Addendum No. 01

Project Name: SLCC Inclusive Restroom Addition

Project No.: 2022560.01

Issued: 12/5/2023

G001

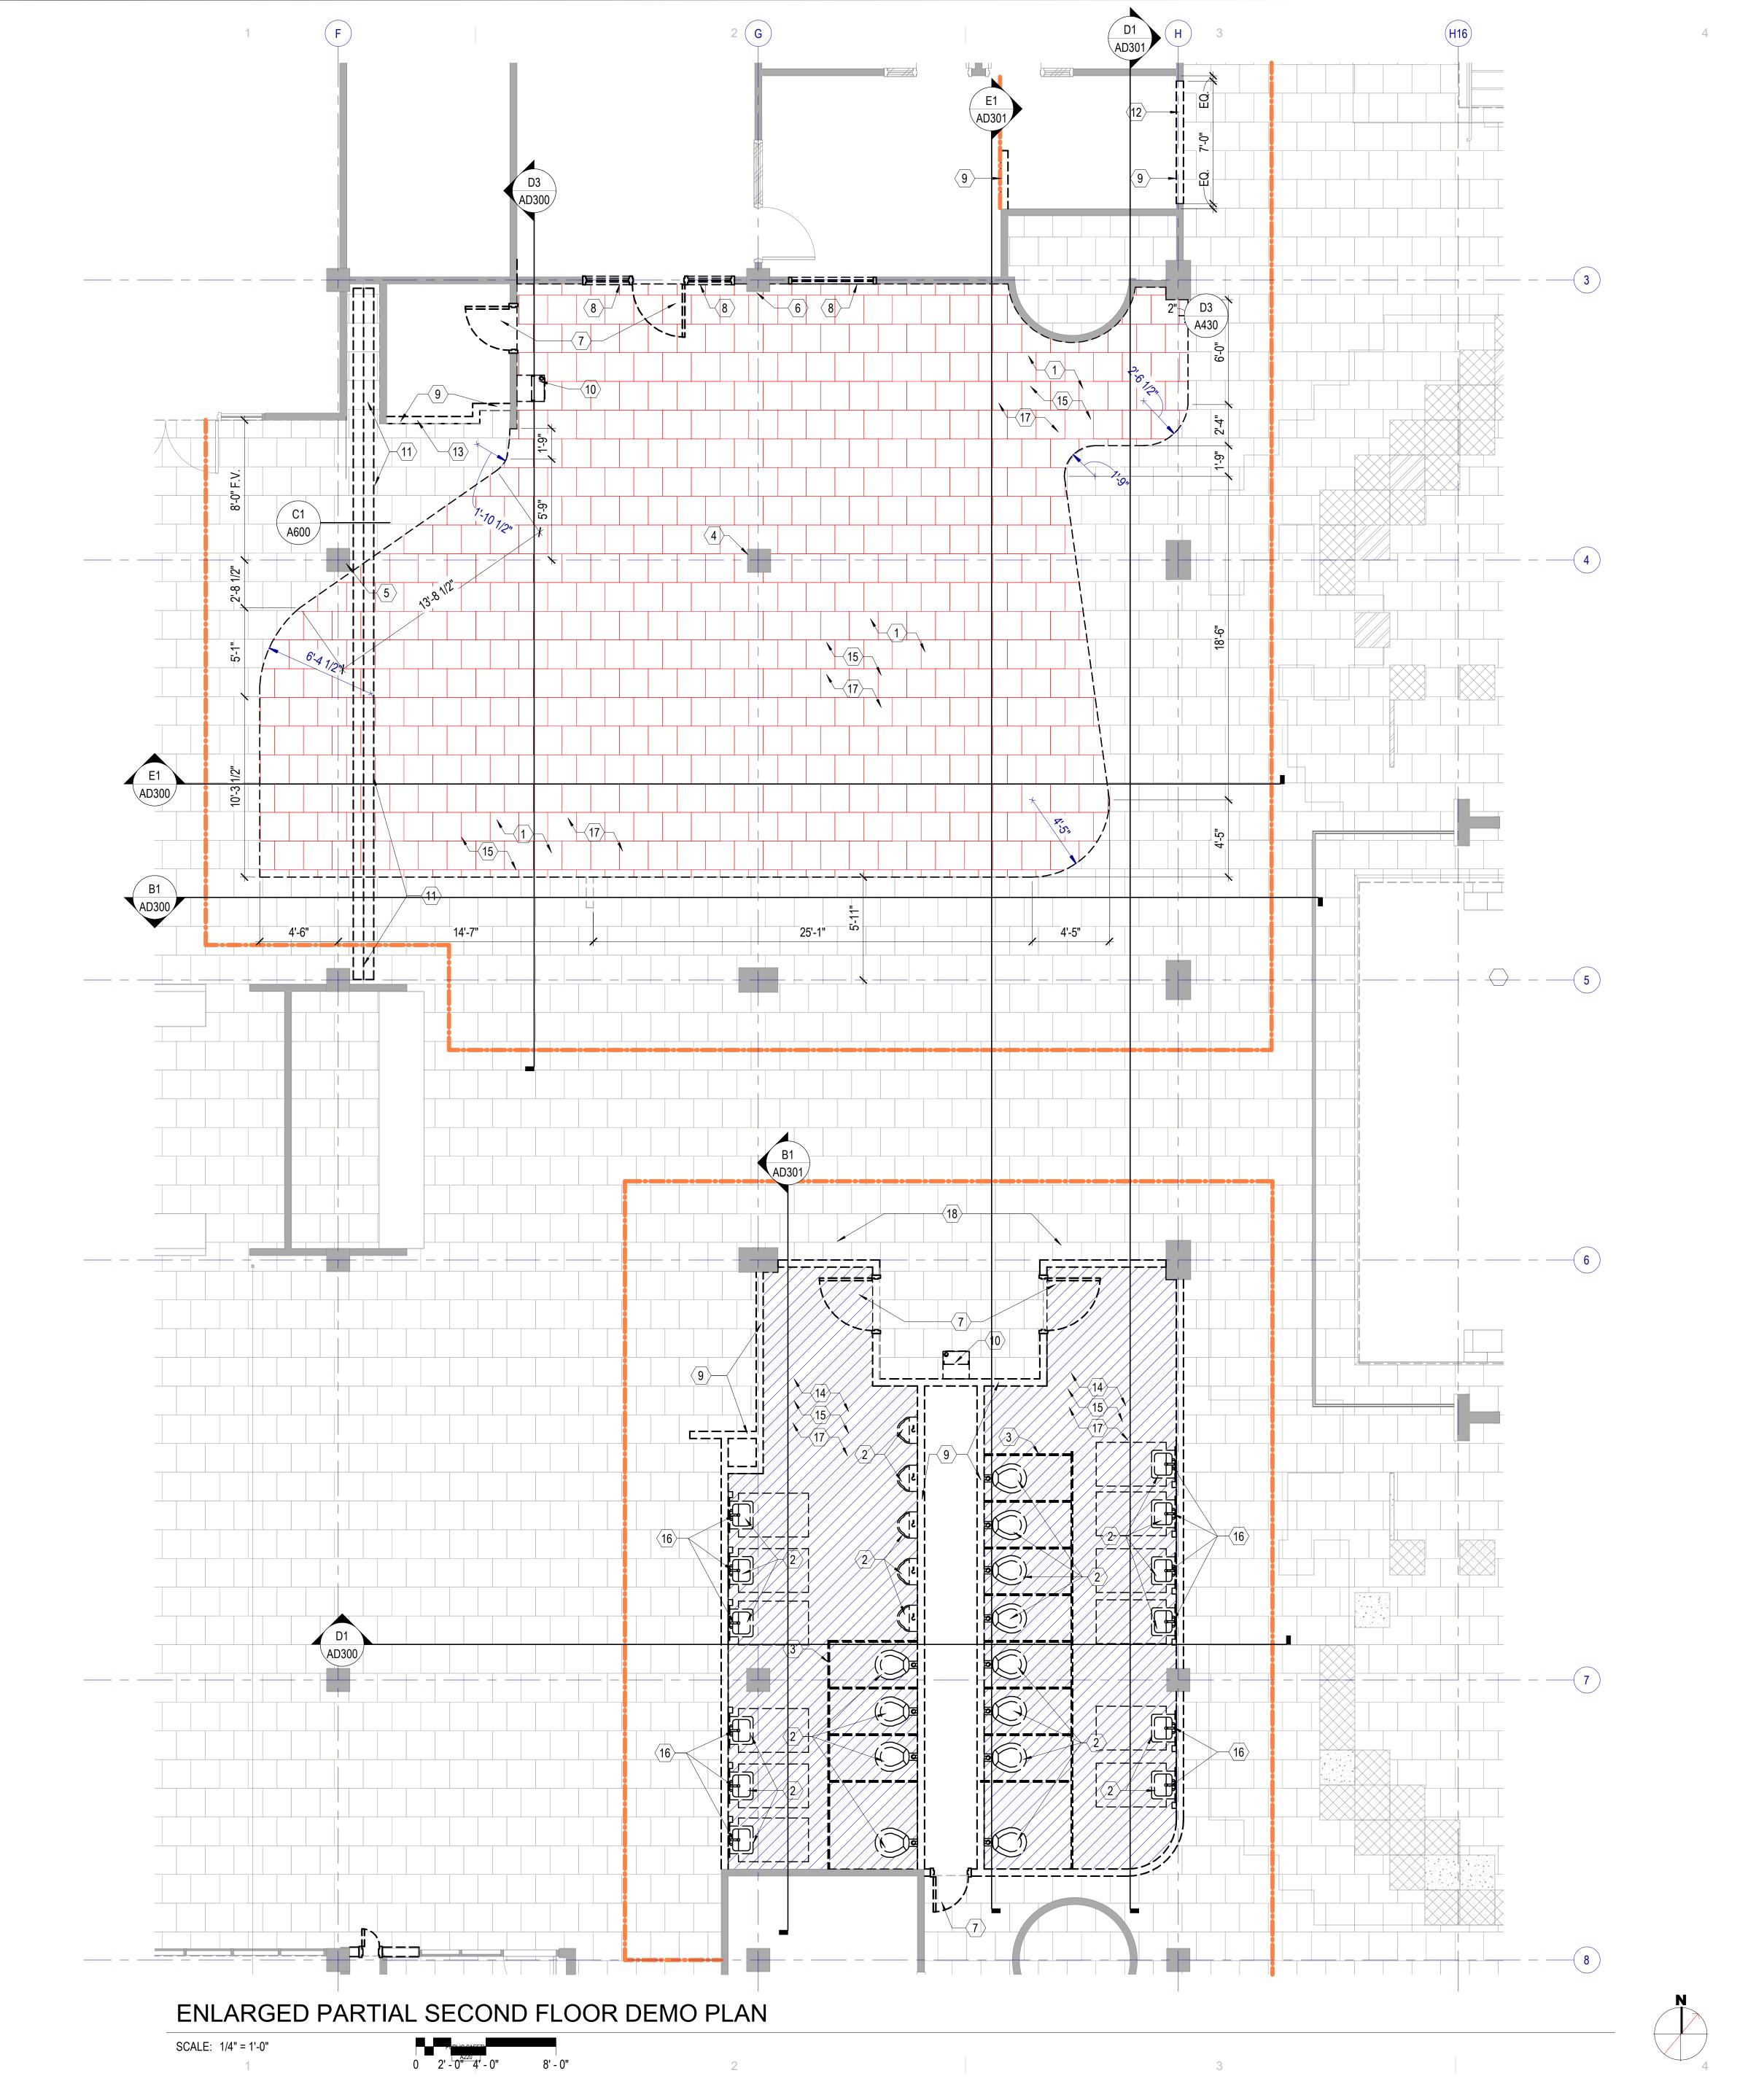
B1.1 Sheet G001 - INDEX SHEET:

Phasing note added to the sheet for demolition and new construction clarification.

- 11. Question: Can you add a more definitive note about project phasing to the cover page or something similar? The only note about phasing is in a keynote in the demo plans and there will probably be a lot of subcontractors that miss that. SHEETS G001 AND AD102 HAVE BEEN UPDATED TO INCLUDE THE PHASING NOTE.

AD102

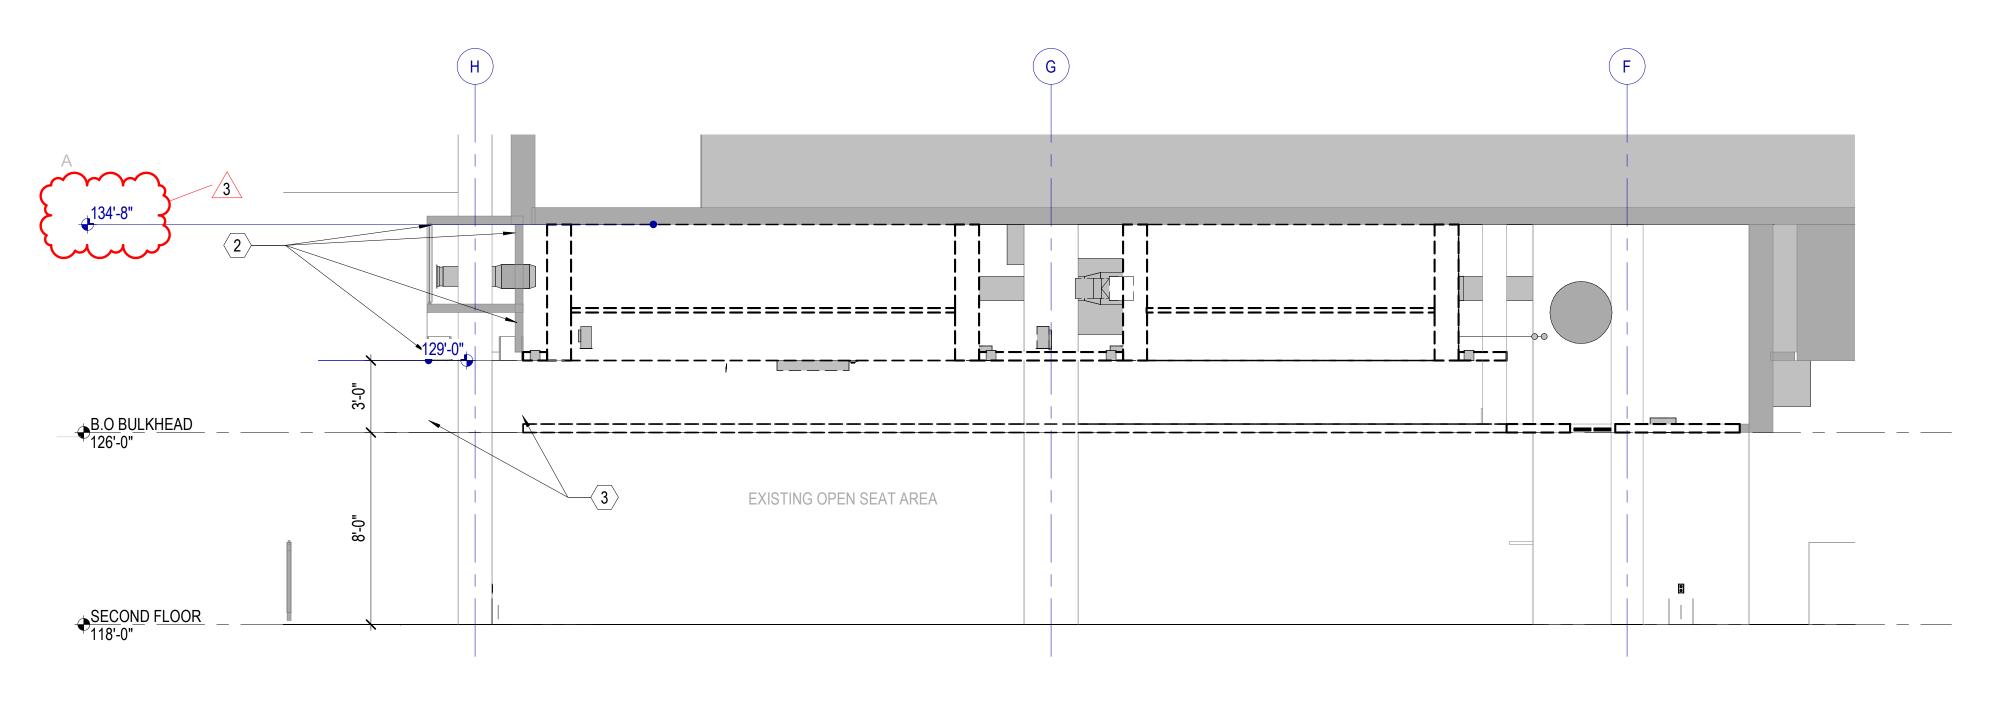
B1.2 Sheet AD102 – SECOND FLOOR DEMOLITION PLAN:

Phasing note added to the sheet for demolition and new construction clarification.

DEMOLITION SECTION - EXISTING OPEN SEAT AREA

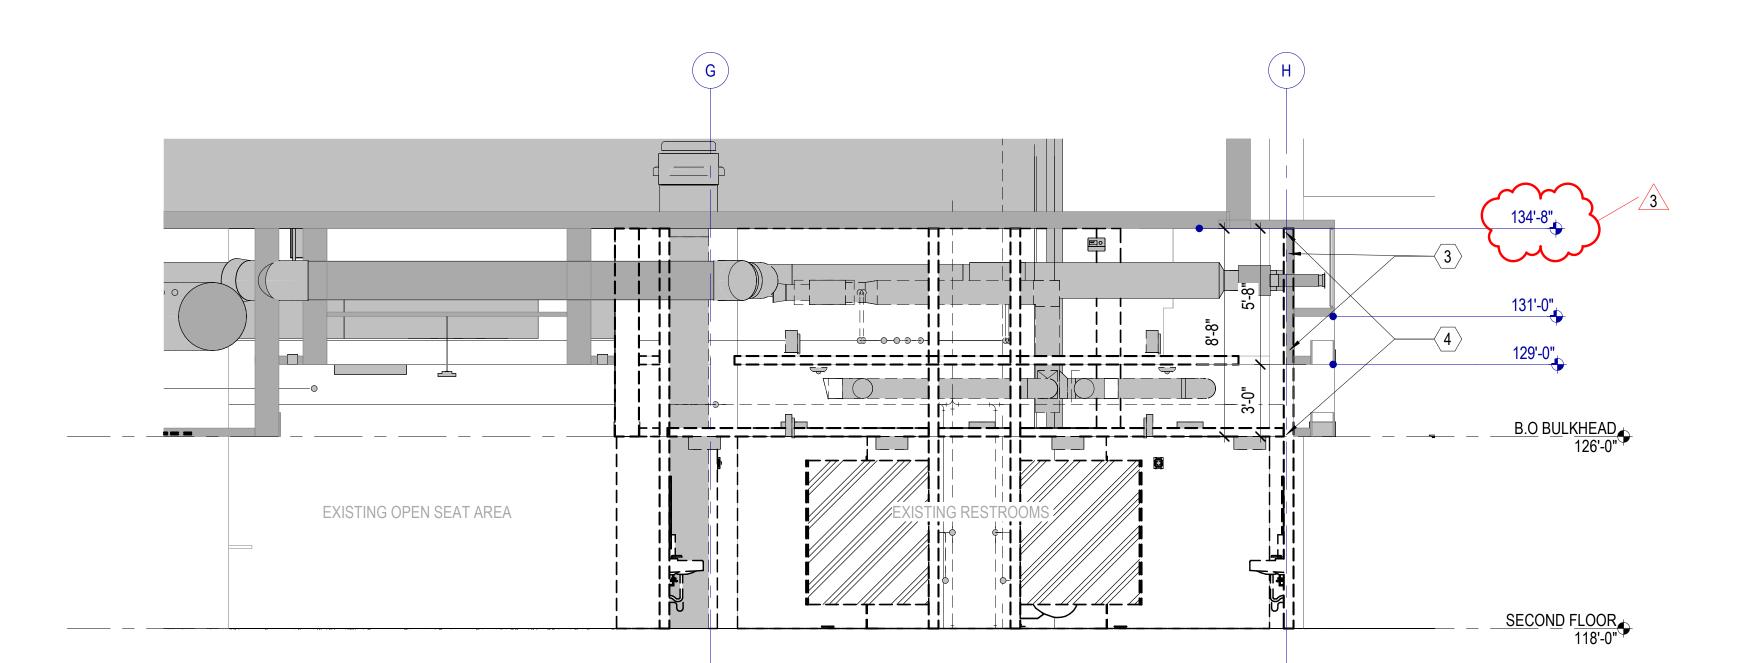
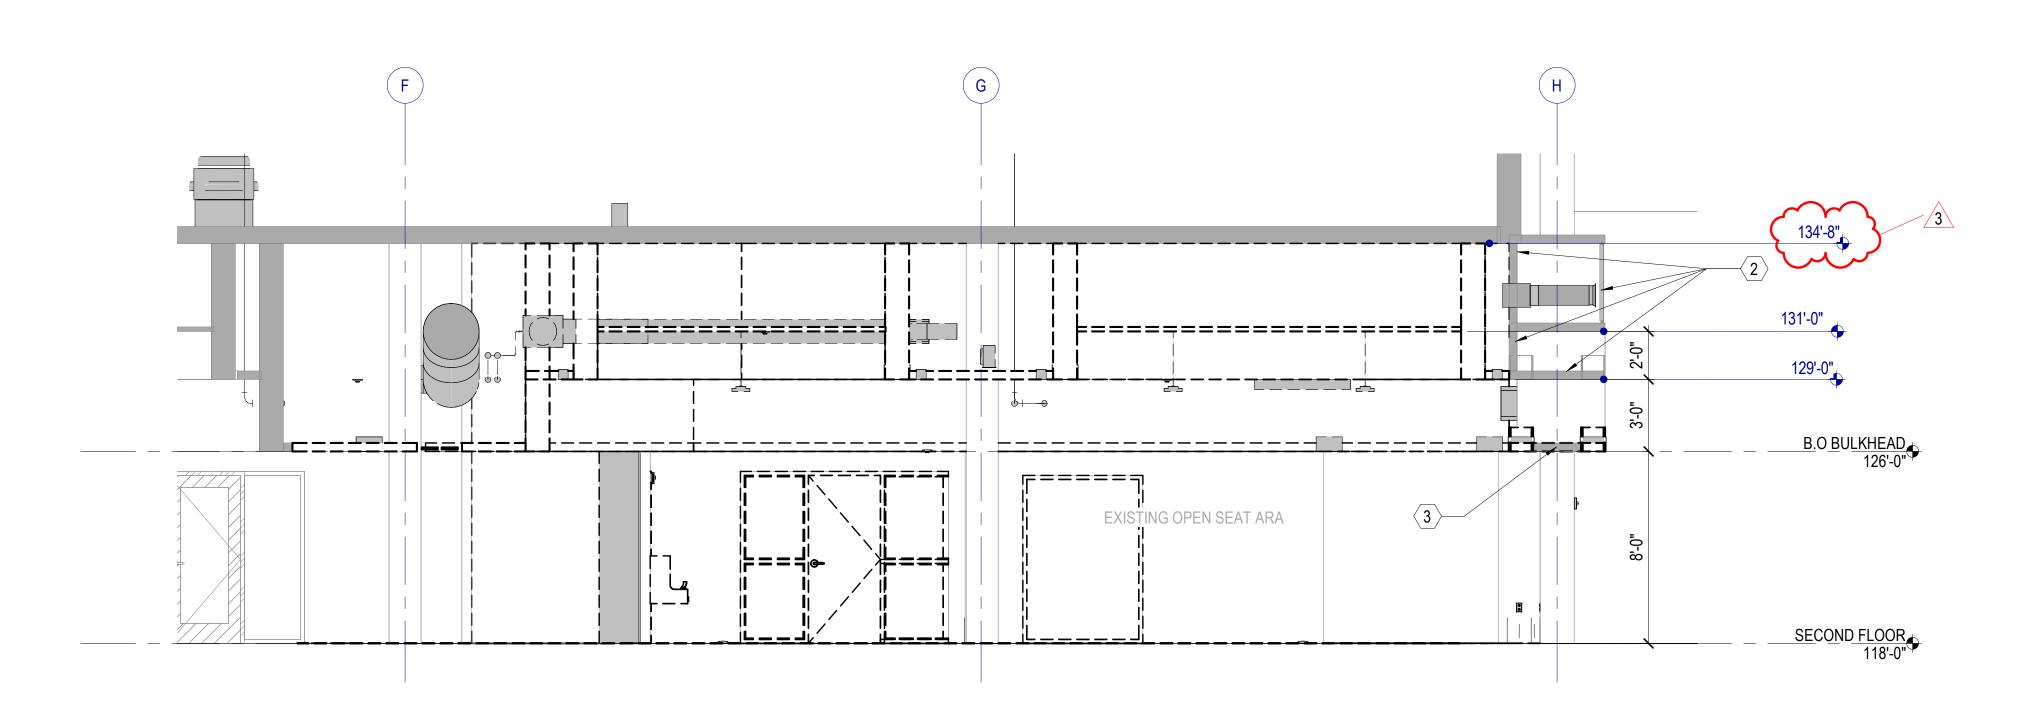
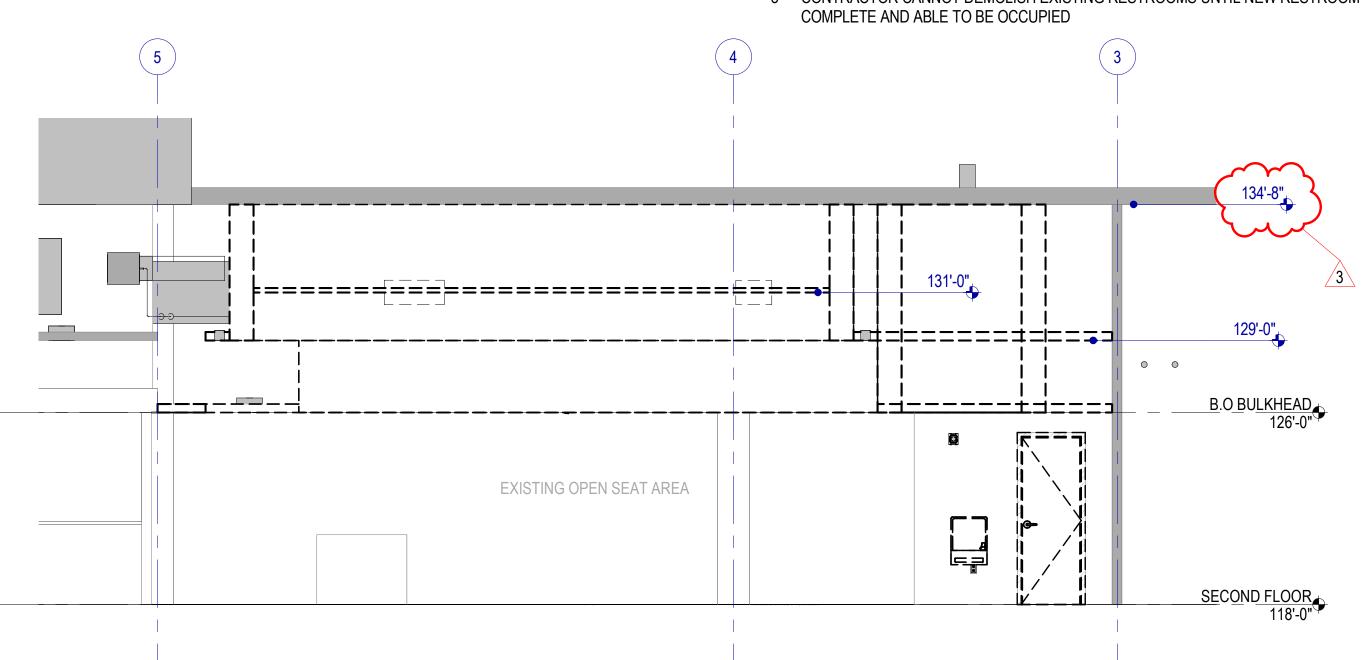
B1.3 Sheet AD300 - DEMOLITION PARTIAL BUILDING SECTIONS:

Deck elevation added to sections.

- 10. **Question:** Several walls are to be framed to deck. Can you please provide the deck height? SHEETS AD300 AND AD301 HAVE BEEN UPDATED TO INCLUDE THE ELEVATION OF THE ROOF DECK.
